# United States Patent and Trademark Office

APPLICATION NO.	FIL	ING DATE	FIRST NAMED INVENTOR	ATTORNEY DOCKET NO.	CONFIRMATION NO.
10/699,152	1	0/31/2003	Flabio Cavalheiro	1479	
7590 02/21/2006			EXAMINER		
Stephen E. Fel	dman		BALSIS, SHAY L		
Suite 701 12 East 41st.				ART UNIT	PAPER NUMBER
New York, NY 10017			1744

#### DETAILED ACTION

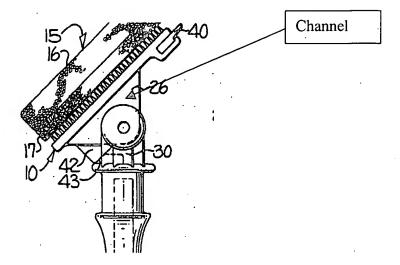
Graham teaches a cleaning device comprising a cleaning member (figure 1, element 15) with a first surface having a scouring surface of loop material (figure 1, element 17) (claims 1 and 8) and a second surface comprising a sponge (figure 1, element 16) (claim 10). There is a base plate (figure 1, element 10) having a plurality of projections (figure 1, element 20) arranged in rows and columns for gripping the first surface of the cleaning member (claim 1, 6). The

projections each have a top segment having opposing ends (figure 6, element 21) and an intermediate section separating the top segment from the base plate by a predefined distance (claim 2). The opposing ends of the projections each have free ends, which terminate at substantially a point, and therefore the opposing ends have a cross section that is thicker at the connection of said ends to the top segment than at said free ends (figure 7) (claims 2, 3, 4). The intermediate section having bottom end defined by the connection of the intermediate section to the base plate and a top end defined by the connection of the intermediate section to the top segment, wherein the cross section is thicker at the bottom end than at the top end (figures 6 and 7) (claim 3). The distance between the end of each free end is substantially the same as the distance between the top end and the bottom end of the intermediate segment (figure 7) (claim 5). The base plate comprises a handle member (figure 1, element 25) including a grasping means that is curved throughout and configured to closely conform to the curvature of the inside of a user's hand and the grasping means is removable from the base plate (figure 5). The handle has a channel formed between a bottom surface of the handle and the base plate. The channel is configured in such a manner as to accept at least part of a user's finger when the handle is grasped (see figure below) (claim 1). There is a connector (27, 32, 33) connecting the base member to the handle. The connector is capable of being disengaged for removing the handle from the base plate (figure 5) (claim 1). Graham teaches all the essential elements of the claimed invention however fails to teach that projection is T-shaped with the top segment having a substantially straight upper surface. Nortman teaches fastening hooks having a T-shaped projection each with a top segment that is substantially straight (figure 5, element 60). The projections have a lower surface and opposing ends (figure 5, element 77) and an intermediate

Applicant's argument, filed 1/6/06, with respect to the Graham and Hintz and the handles, have been fully considered but are not persuasive. It is shown in the figures above that the cleaning devices of Graham or Hintz could be held in such a manner that a portion of the user's finger (tip) may fit within the channels. While the cleaning devices may not be intended to be held in this manner, a recitation of the intended use of the claimed invention must result in a structural difference between the claimed invention and the prior art in order to patentably distinguish the claimed invention from the prior art. If the prior art structure is capable of performing the intended use, then it meets the claim. Thus since the references are capable of being held in this manner, the references meet the claim limitations.

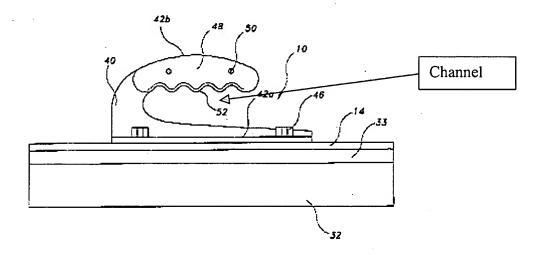
Hintz teaches a cleaning device comprising a cleaning member (figure 3, element 32) with a first surface having scouring surface of loops (figure 3, element 33) (claims 1) and a second surface comprising a sponge (figure 3, element 32). There is a base plate (figure 3, element 14) having a plurality of projections (figure 3, element 34) arranged in rows and columns for gripping the first surface of the cleaning member (claim 1). The projections each have a top segment having opposing ends and an intermediate section separating the top segment from the base plate by a predefined distance (claim 1). The base plate comprises a handle member (figure 3, element 40) including a grasping means that is curved throughout and configured to closely conform to the curvature of the inside of a user's hand and the grasping means is removable from the base plate (figure 2). The handle has a channel formed between a bottom surface of the handle and the base plate. The channel is configured in such a manner as to accept at least part of a user's finger when the handle is grasped (see figure below) (claim 1). There is a connector (46) connecting the base member to the handle. The connector is capable of

being disengaged for removing the handle from the base plate (figure 2) (claim 1). Hintz teaches all the essential elements of the claimed invention however fails to teach that projection is T-shaped with the top segment having a substantially straight upper surface. Nortman teaches fastening hooks having a T-shaped projection each with a top segment that is substantially straight (figure 5, element 60). The projections have a lower surface and opposing ends (figure 5, element 77) and an intermediate section (figure 5, element 58) separating the top segment from the base plate by a predefined distance. The opposing ends of the projections each have free ends, which terminate at substantially a point (figure 5), and therefore the opposing ends have a cross section that is thicker at the connection of said ends to the top segment than at said free ends (figure 5). The intermediate section having bottom end defined by the connection of the intermediate section to the base plate and a top end defined by the connection of the intermediate section to the top segment, wherein the cross section is thicker at the bottom end than at the top end (figure 5). The distance between the end of each free end is substantially the same as the distance between the top end and the bottom end of the intermediate segment (figure 5).

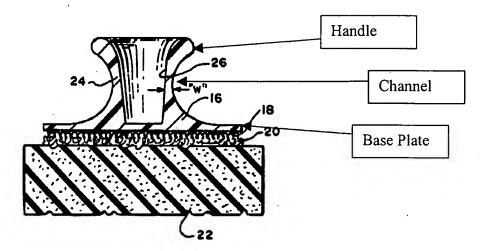
Fay teaches a cleaning device comprising a handle (11) and base plate (1). There is a cleaning member (15) attached to the base plate. The handle comprises a channel (13) between the bottom surface of the handle and the base plate. There is a connector (12) connecting the handle and the base member. The connector allows the handle to be removed from the base plate.

Nortman teaches fastening hooks having a T-shaped projection each with a top segment that is substantially straight (figure 5, element 60). The projections have a lower surface and opposing ends (figure 5, element 77) and an intermediate section (figure 5, element 58) separating the top segment from the base plate by a predefined distance. The opposing ends of the projections each have free ends, which terminate at *substantially* a point (figure 5), and therefore the opposing ends have a cross section that is thicker at the connection of said ends to the top segment than at said free ends (figure 5). The intermediate section having bottom end defined by the connection of the intermediate section to the base plate and a top end defined by the connection of the intermediate section to the top segment, wherein the cross section is thicker at the bottom end than at the top end (figure 5). The distance between the end of each free end
